Demers 62911 and newer inverter

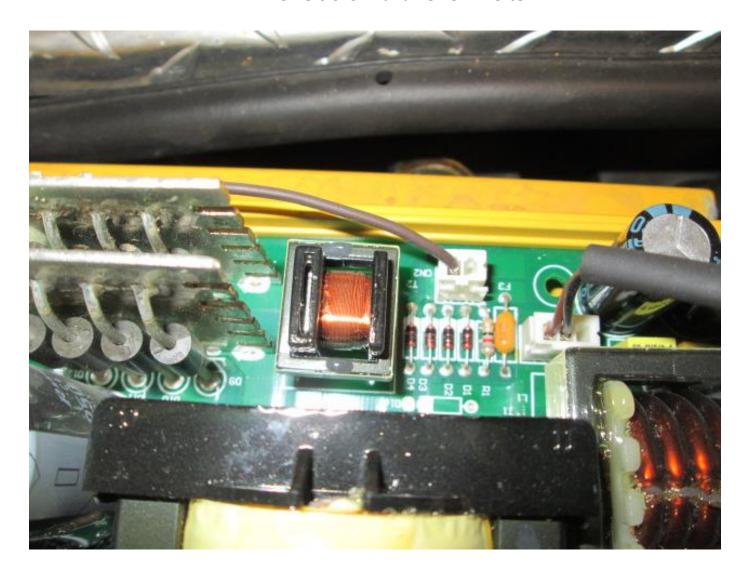
- Transfer brown wire from existing inverter to the new inverter this is the on/off switch to allow the inverter to only work when the connect switch is on and the vehicle is running.
- The brown wire comes from M10J2-5 in the electrical diagram
